Pre-Application Conference

Subject: Minor Partition(MIP)

Location: 3340 Arbor Drive (Assessor's Map 21E 14D tax lot 2500)

File No: PA-14-11

(Robinwood Creek WRA at rear of property)

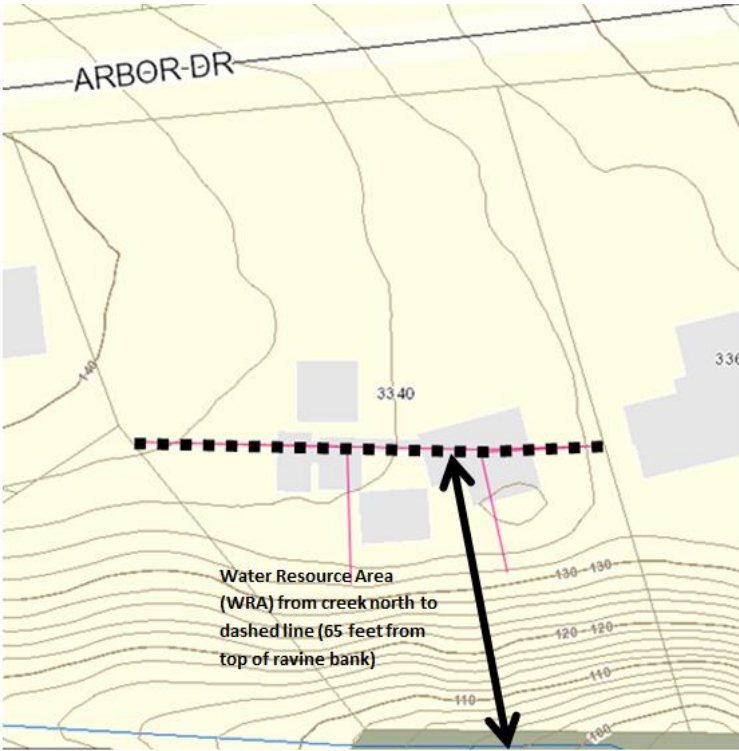
The property is heavily treed, many potentially significant. The rear quarter of the site is part of the Robinwood Creek drainageway with slopes transitioning to over 25%. There is a riparian corridor designation attached to Robinwood Creek meaning that no development should occur within 115 feet of that creek. Also there is a building setback of 65 feet from the top of the ravine which is generally shown in the map below with the dashed horizontal line. While the existing house is non-conforming in

that it falls within the 65 foot setback, any new homes would have to be built outside of that setback area. *(At the present time the setback from the ravine top of bank is 65 feet. Proposed code amendments to CDC Water Resource Area [WRA] Chapter 32 recommend a reduced setback of 50 feet. Those amendments have yet to be approved. City Council is expected to consider the amendments in late May 2014. Similarly, the riparian setback of 115 feet is proposed to be reduced to 100 feet.)*

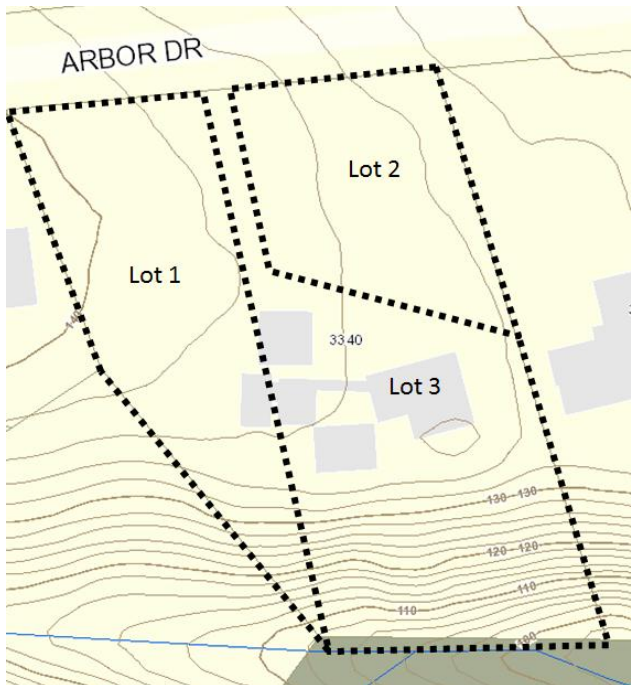
The partition would produce three lots. A generalized plan is shown below with each lot exceeding 10,000 square feet. Other configurations are possible but the applicant wanted lot 1 to extend into and have legal access to the WRA. Also the flaglot alignment could be modified and/or replaced by an access easement.

Lot 1 would be west of the house with direct frontage on Arbor Drive. (Lot 1 is shown on the map below as extending from Arbor Drive to Robinwood Creek. This configuration may be in violation of the CDC 11.070(4) which stipulates that the lot depth , exclusive of Type I and II land (drainageway), cannot exceed 2.5 times the width. That provision may be eliminated by City Council as part of an April code amendment. If it is not eliminated, Lot 1 may have to be reconfigured. A site visit on 2-26-14 indicated that the slope may extend far enough northwards on lot 1 to the extent that the 2.5 times rule will not be violated but that will only be definitively determined by staff after survey and slope analysis by the applicant's consultant.)

Lot 2 would be in front of/north of the house. That site is shown in the photograph below. This lot would have frontage on Arbor Drive.

Lot 3, with the existing house, would be a flag lot with a 15 foot wide flag stem. (*The square footage of the stem cannot count to any lot's square footage.*) The applicant proposes to retain this house.

Lot 3's northern property line would have to be at least 20 feet from the existing house to meet the minimum front yard setback. The common lot line between lots 1 and 3 would have to be at least 7.5 feet from the side of the existing house. The shape of the lots should be generally proportionate and meet the dimensional standards of the R-10 zone. Extensively gerrymandered/irregular lot lines to achieve the minimum lot size are not permitted. In the event that the existing house was demolished, the replacement house would have to meet the WRA setbacks. That could result in a long narrow Ranch-style house design on an east-west axis.

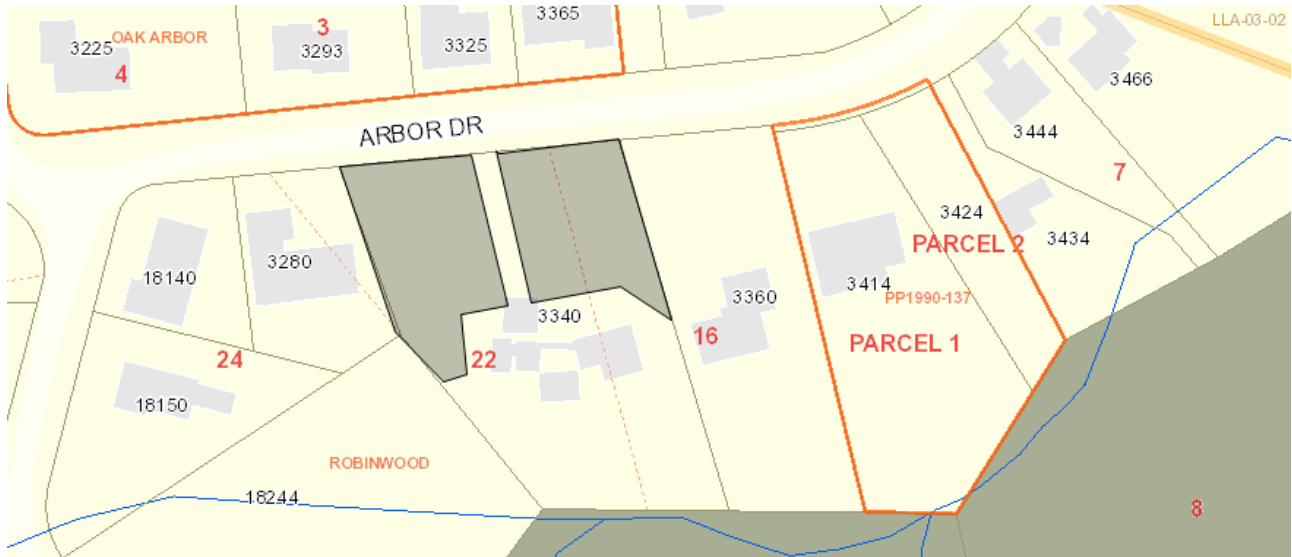
While it does “gerrymander” the lot lines, as discouraged by the CDC, below is an example of how the house could be kept while still achieving three lots of the right size without violating the “2.5 times” rule, plus a stem for the existing house:

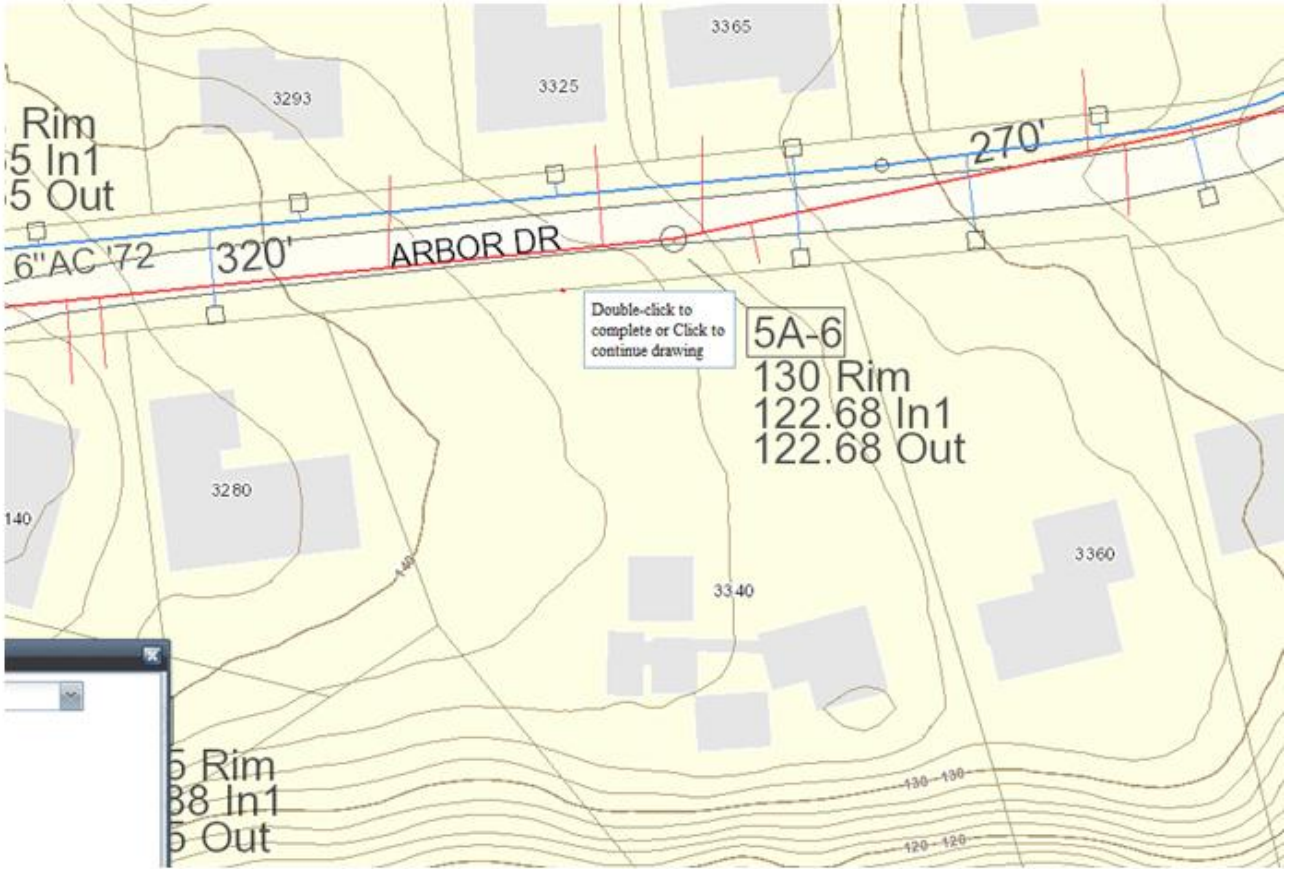
Utilities. Red is sewer. The sewer line is 7.5 feet below the manhole elevation so that looks good. The blue/water line is a 6".
